**ATTACHMENT 8  
LICENSE AMENDMENT REQUEST  
EXTENDED POWER UPRATE  
CORE OPERATING LIMITS REPORT  
MARKUPS**

**FLORIDA POWER & LIGHT  
ST. LUCIE UNIT 2**

## LIST OF PAGES

### Core Operating Limits Report

FIGURE 3.1-1a  
Allowable Time to Realign CEA vs. Initial  $F_r^T$

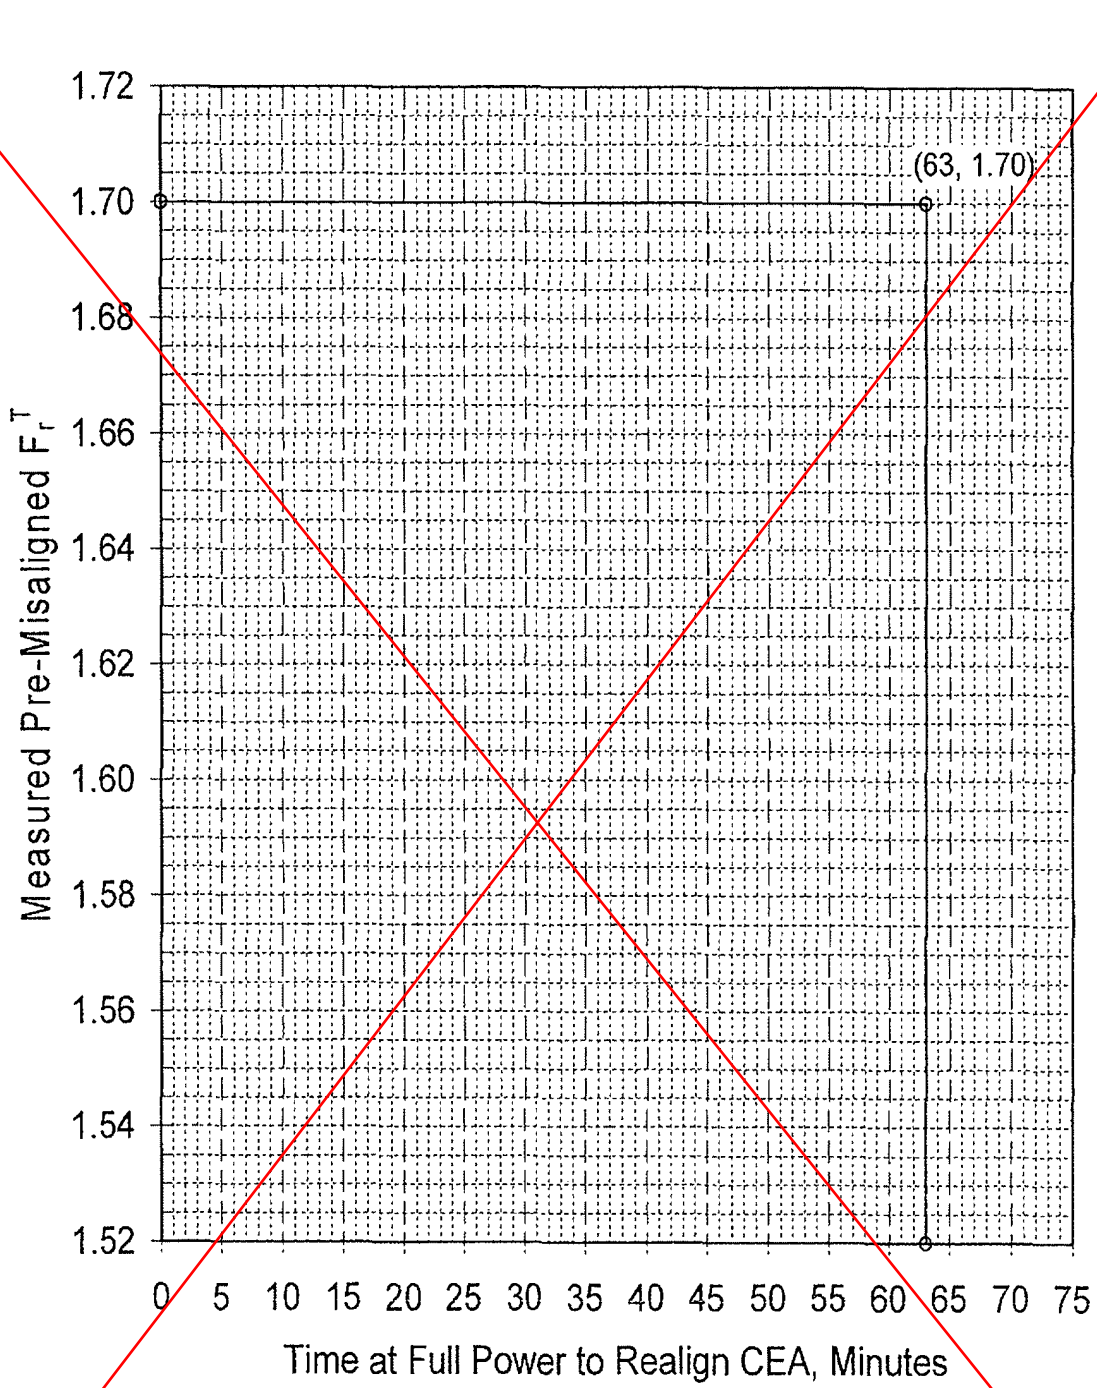
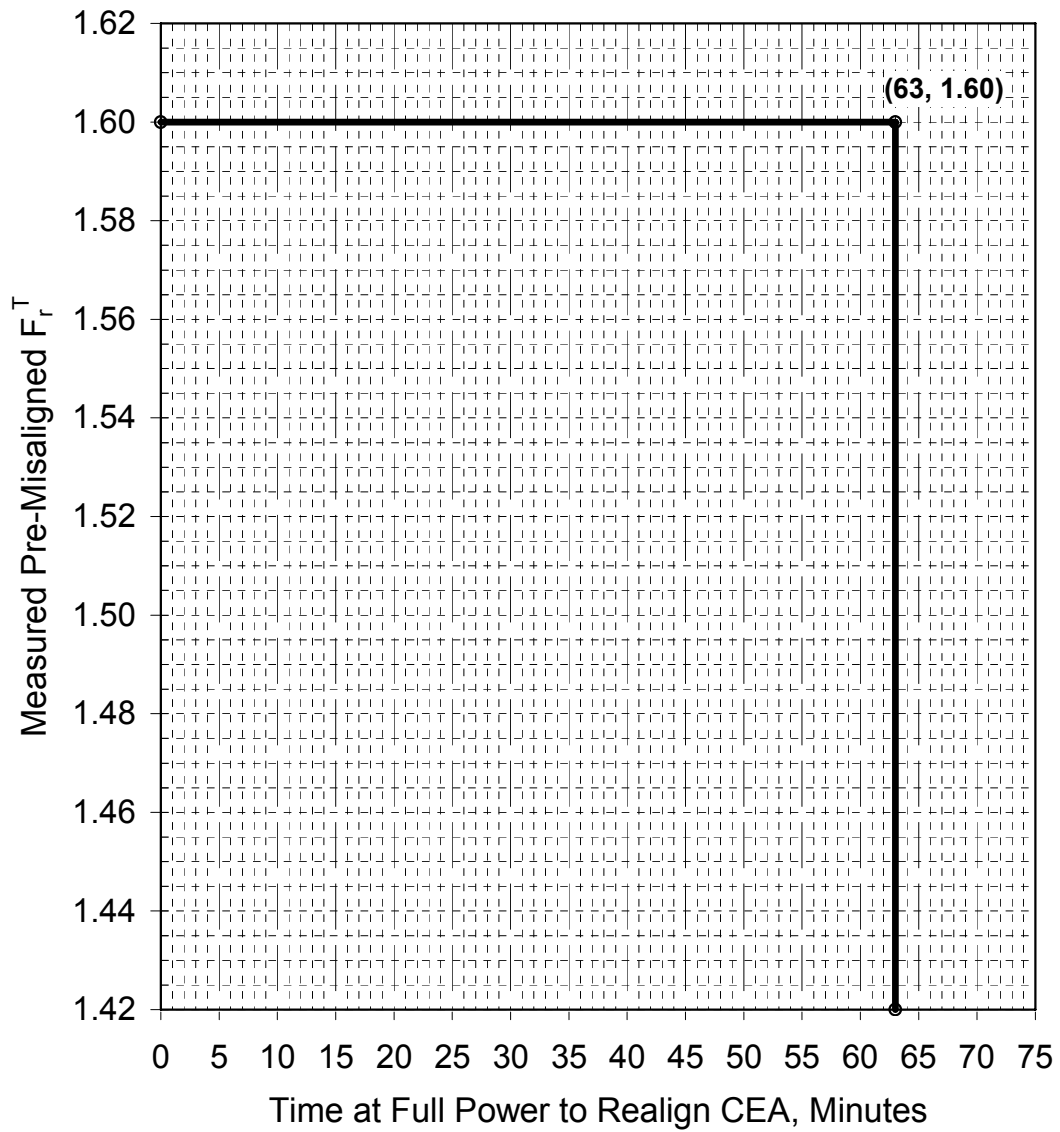
8 of 18 (replaced by Proposed COLR Figure 3.1-1a)

Proposed COLR Figure 3.1-1a

FIGURE 3.2-3  
Allowable Combinations of THERMAL POWER and  $F_r^T$   
(The expression specified in the Figure may be used for  $F_r^T$  at other power levels)

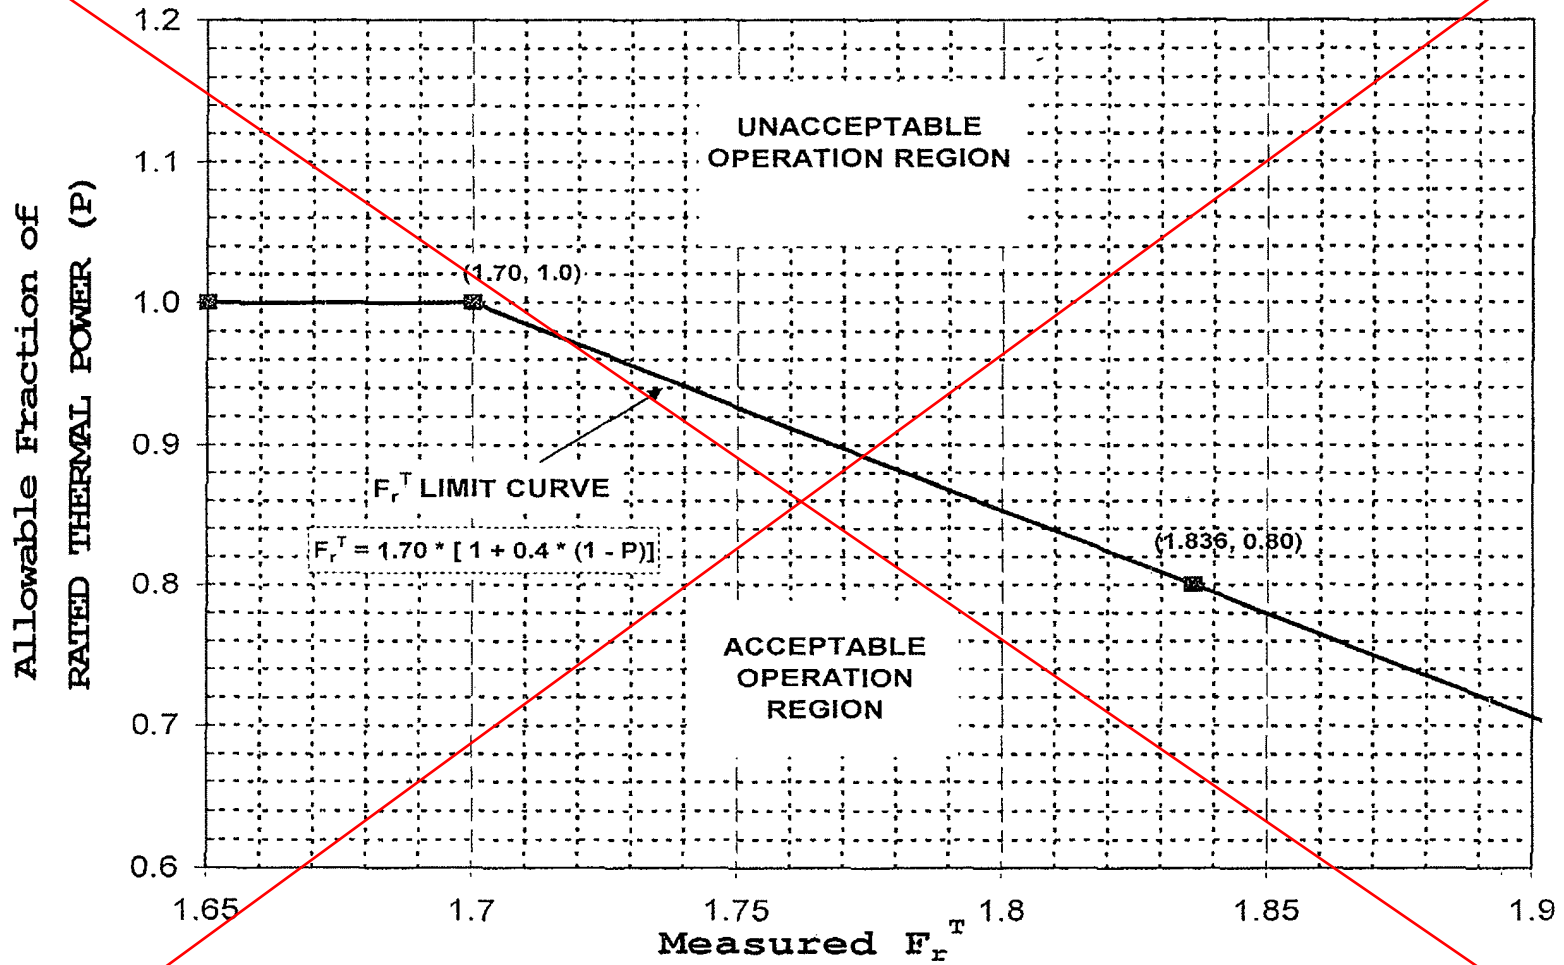
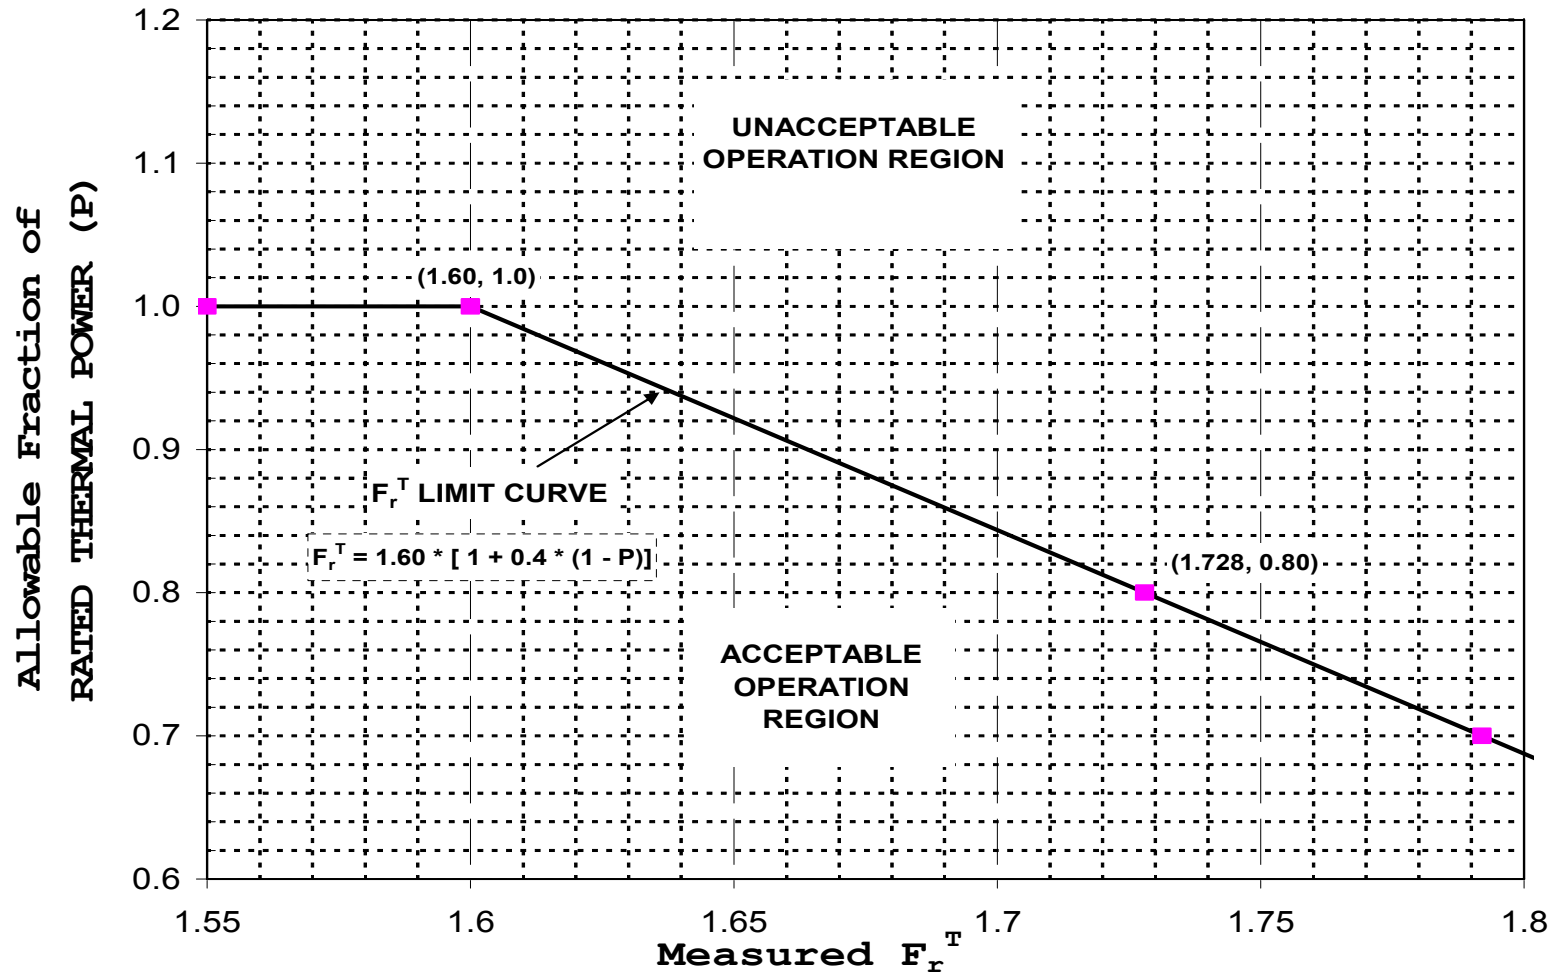
12 of 18 (replaced by Proposed COLR Figure 3.2-3)

Proposed COLR Figure 3.2-3
